**COLLEGE OF DUPAGE
REGULAR BOARD MEETING**

McAninch Arts Center (MAC) 153 Classroom Renovation Project General Contractor

This addendum is being issued to update the specifications and provide additional information.

EXHIBIT A – QUESTIONS AND ANSWERS

PROTECTION PLANS

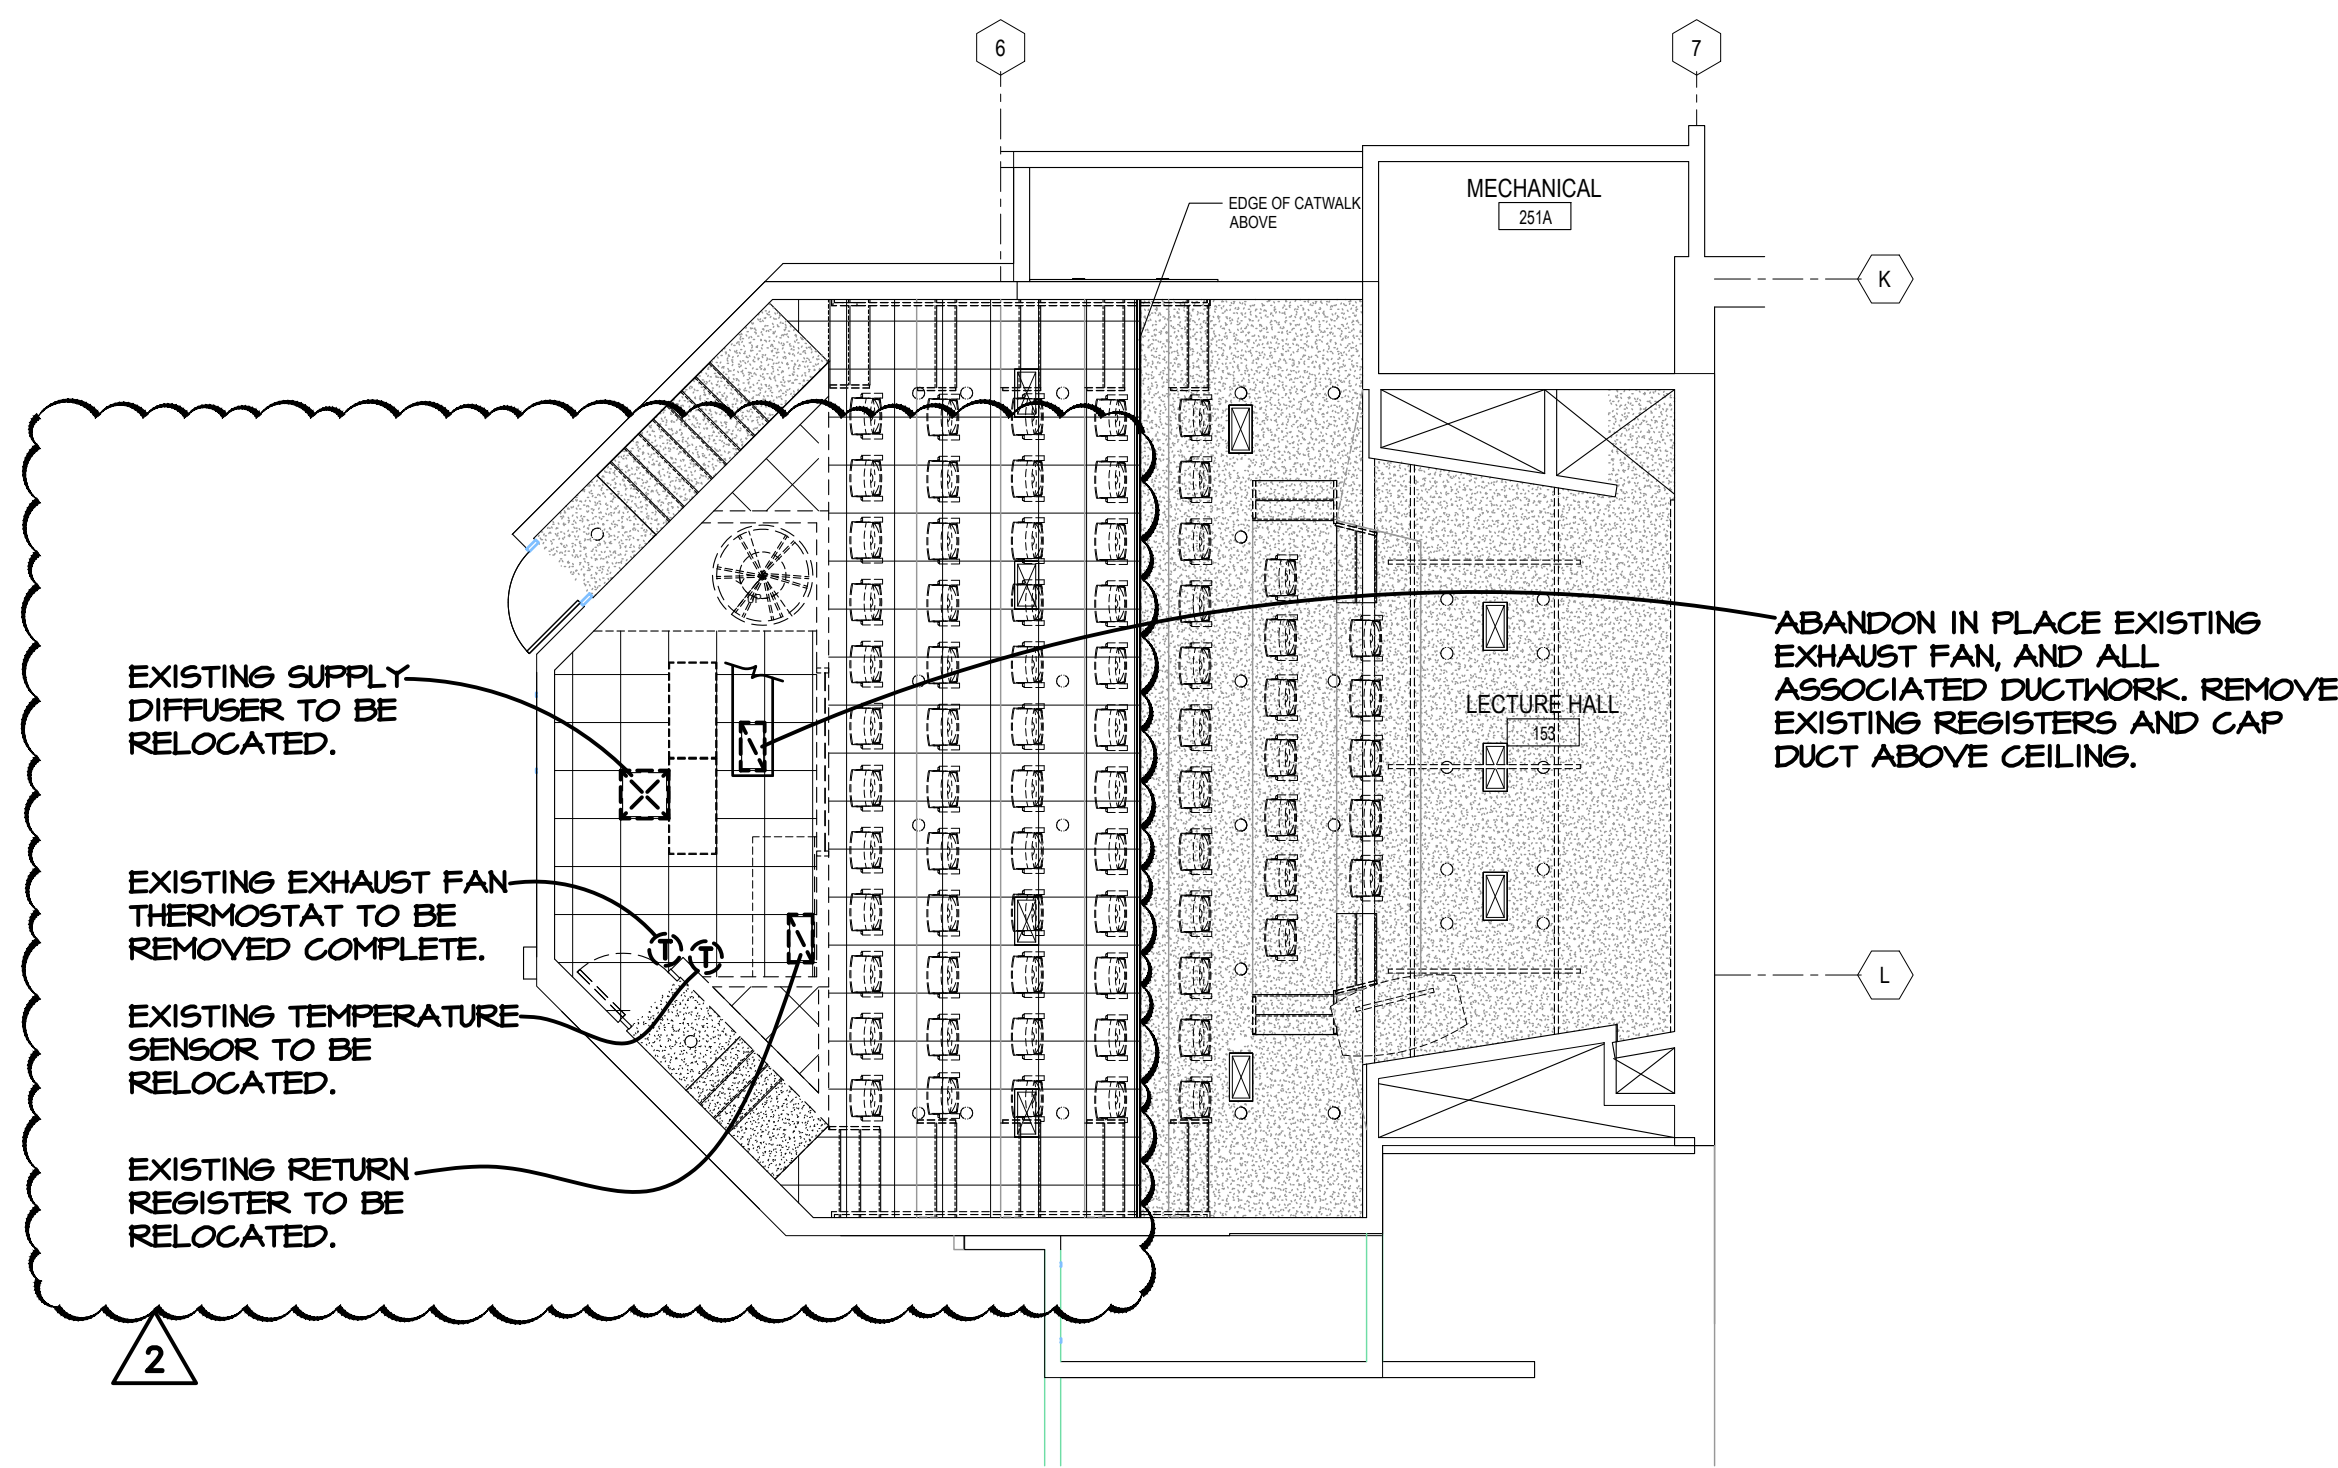
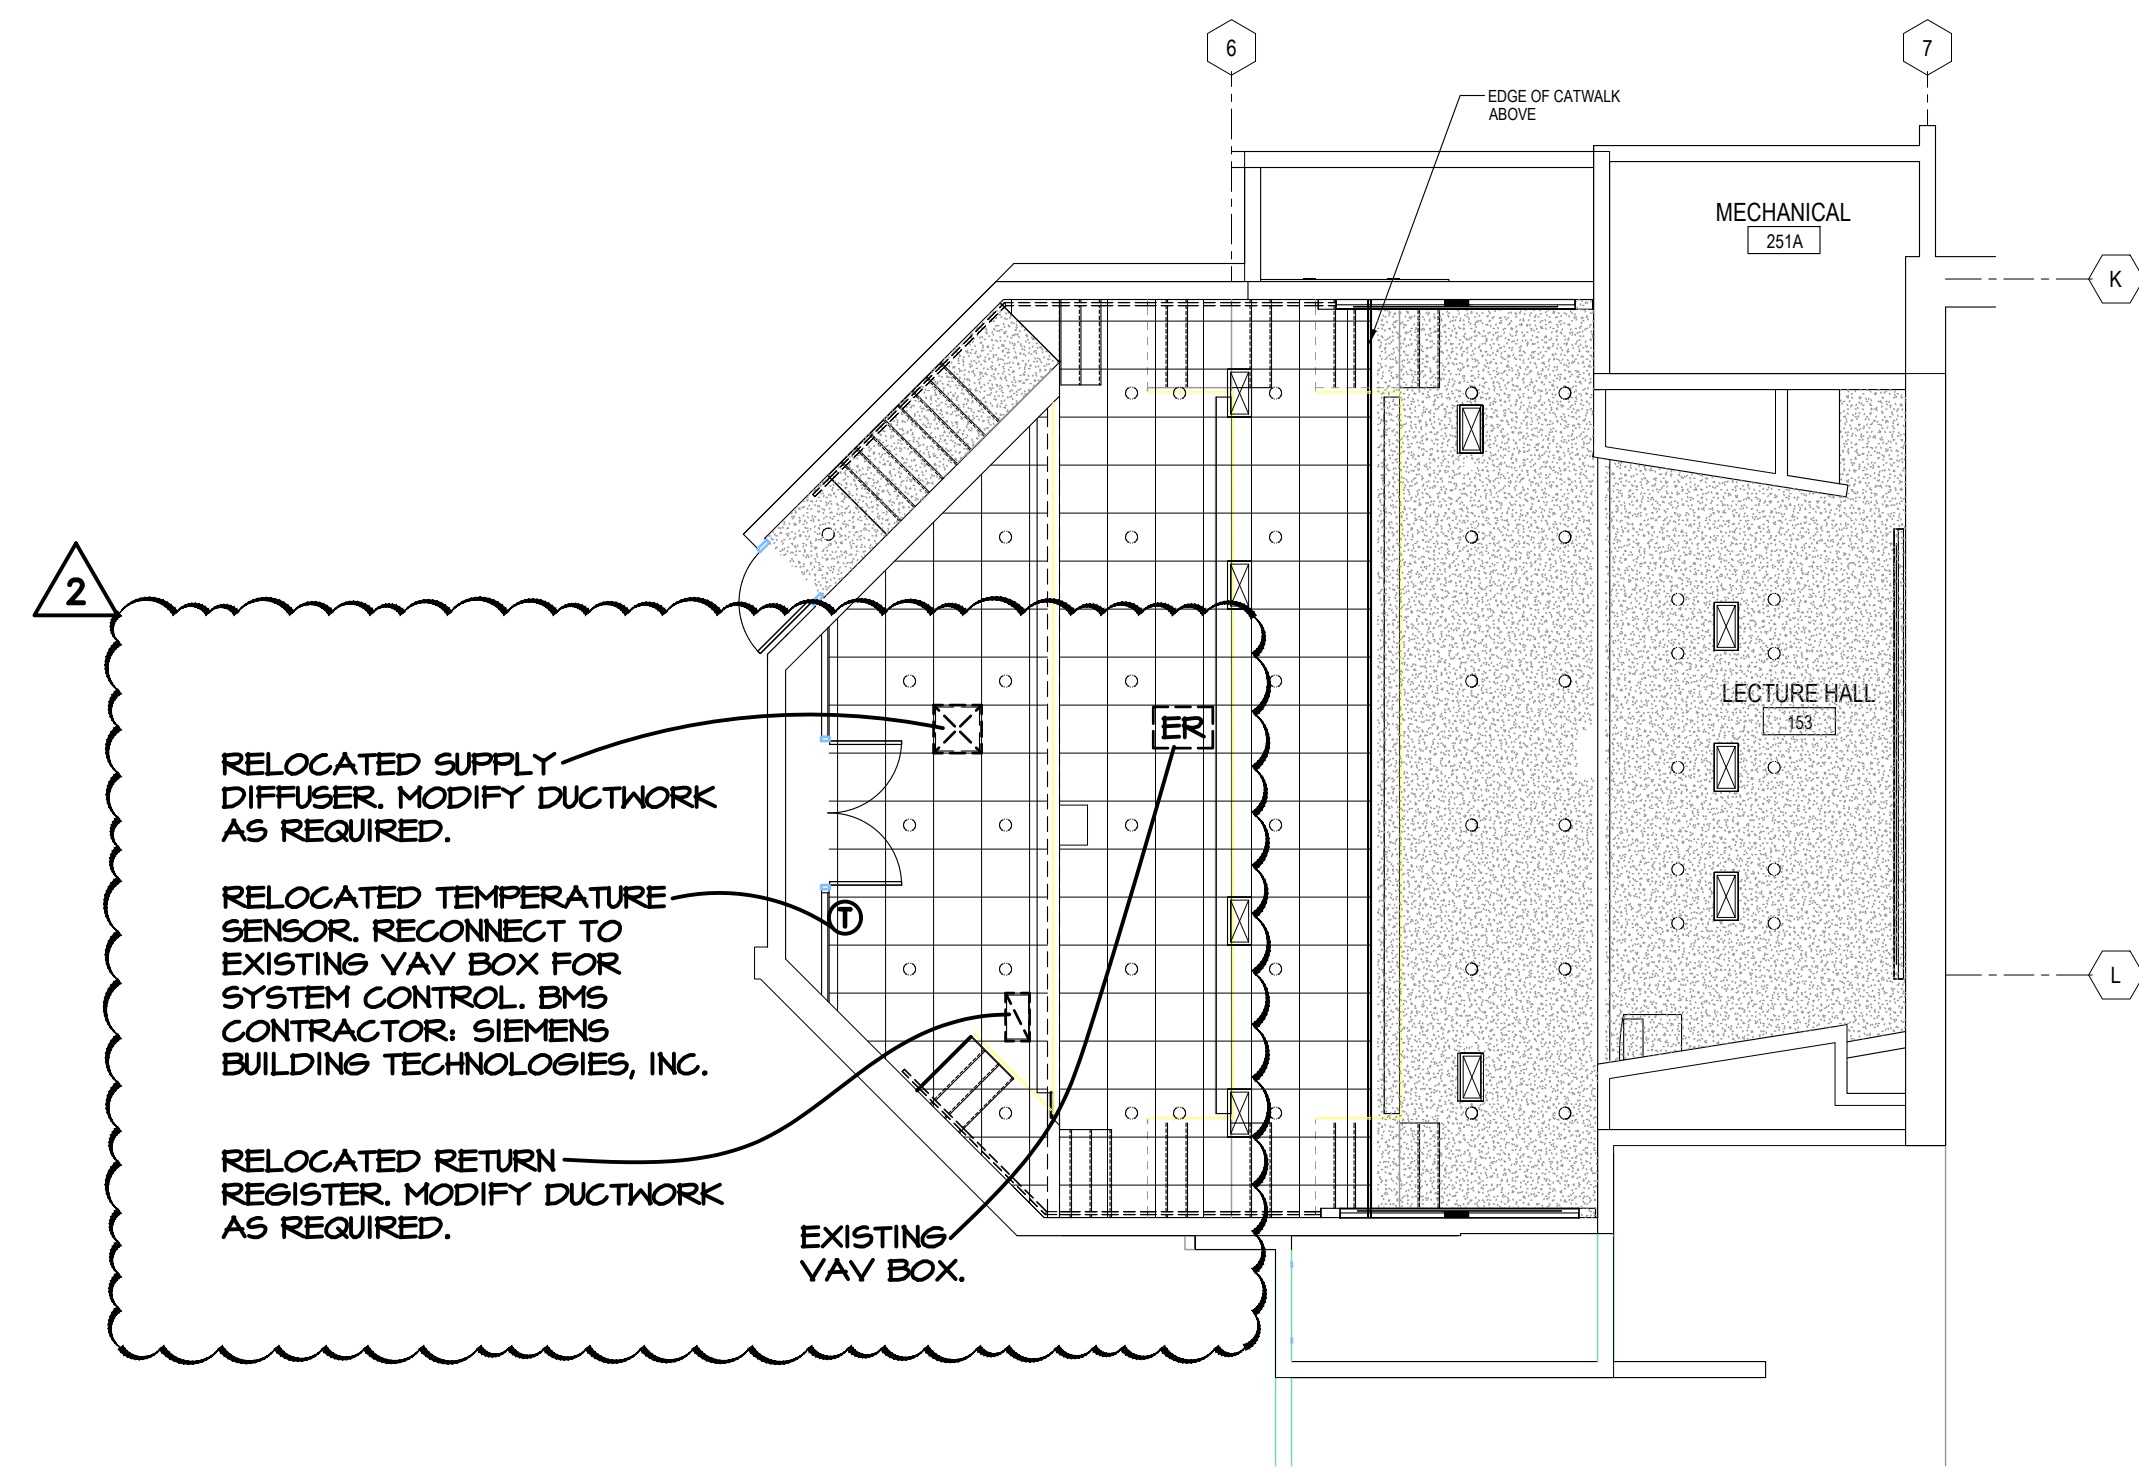
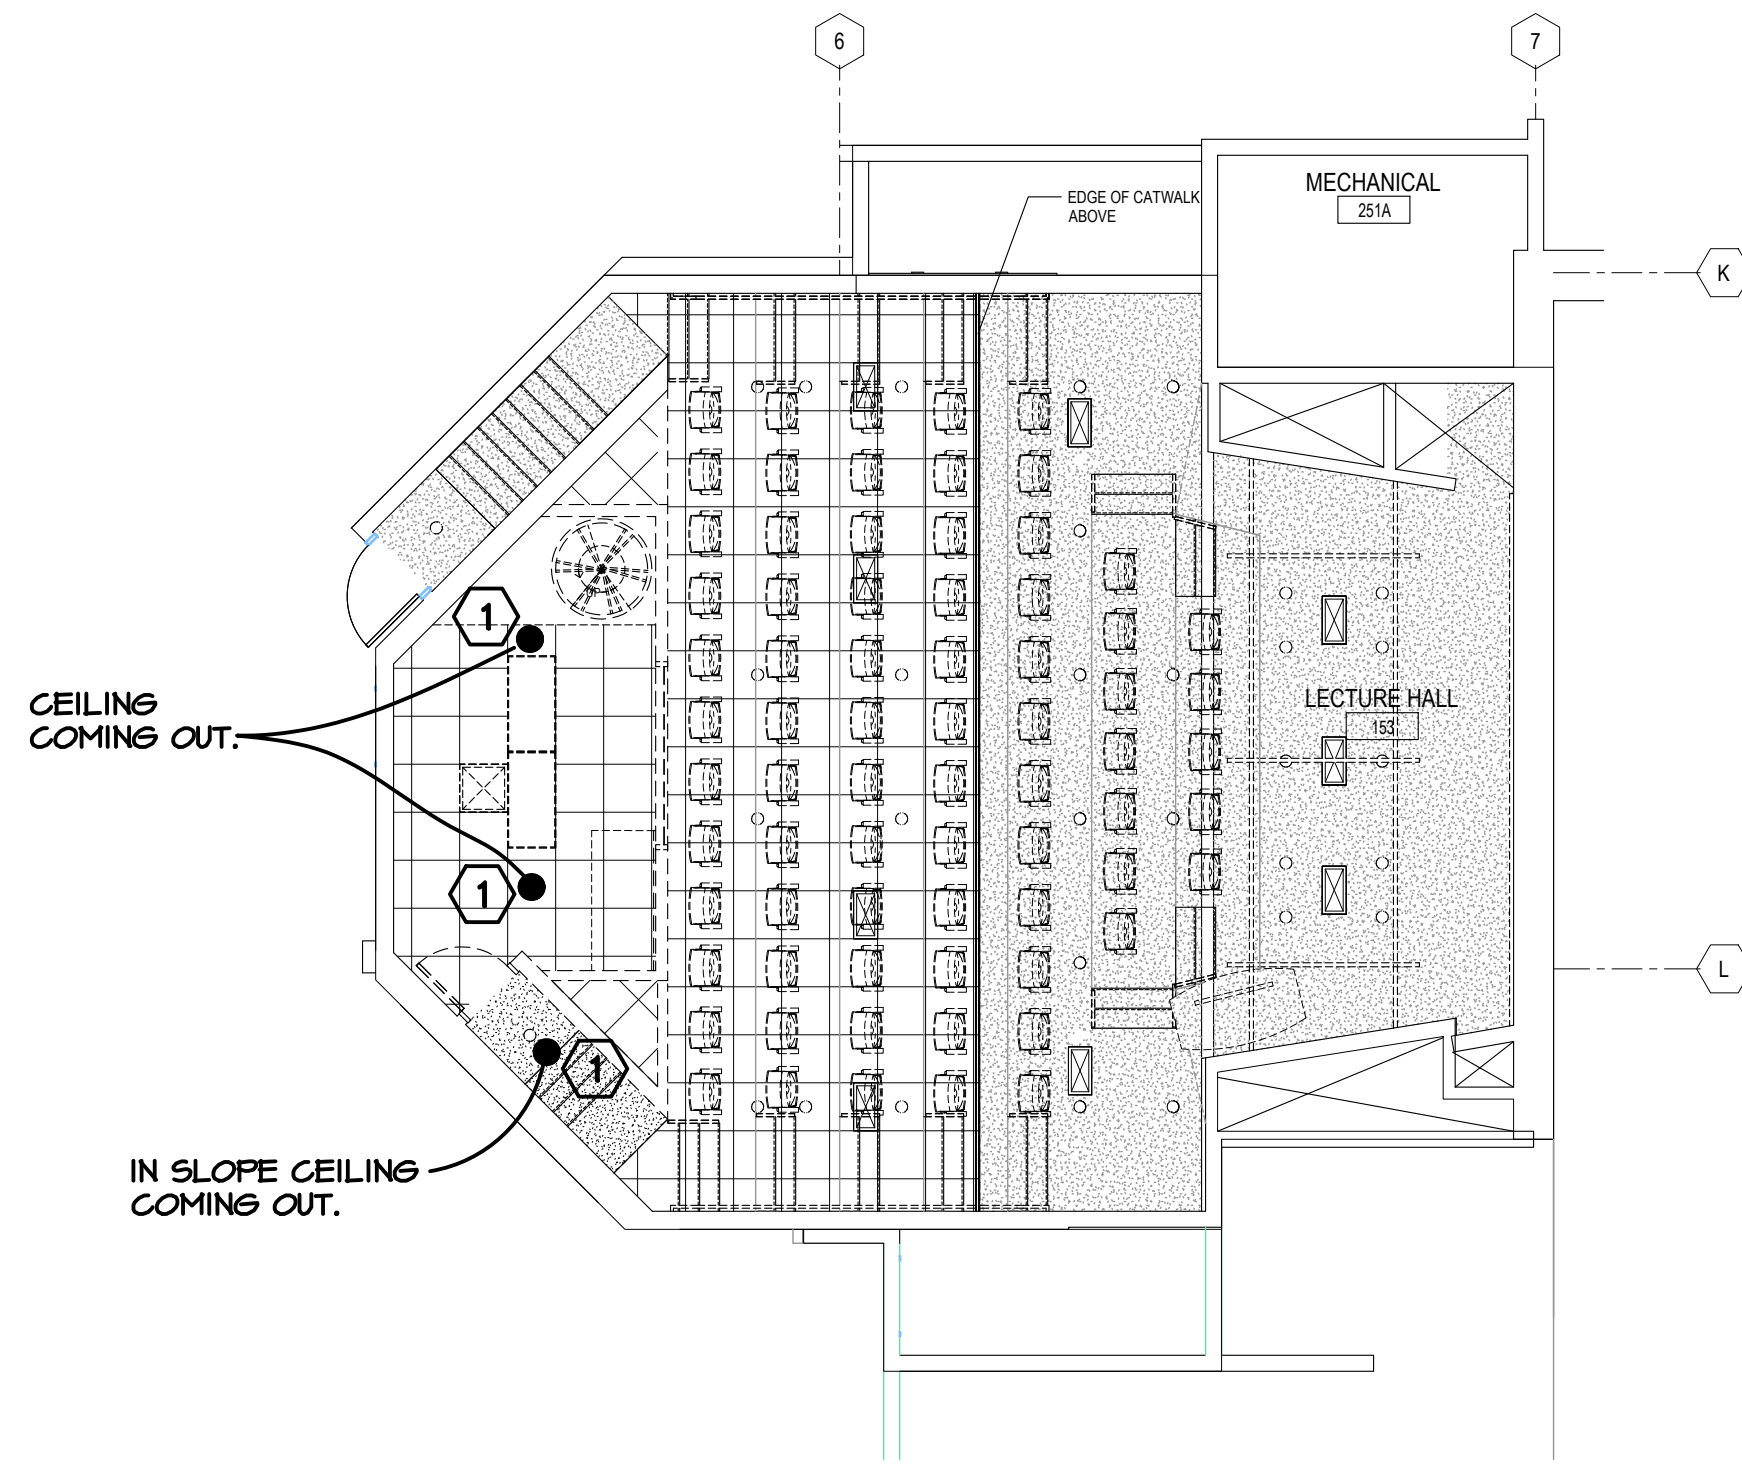
Q4 – Describe HVAC work at the existing control room.

A4 – See revised drawing MFP11-01 issued with this addendum.
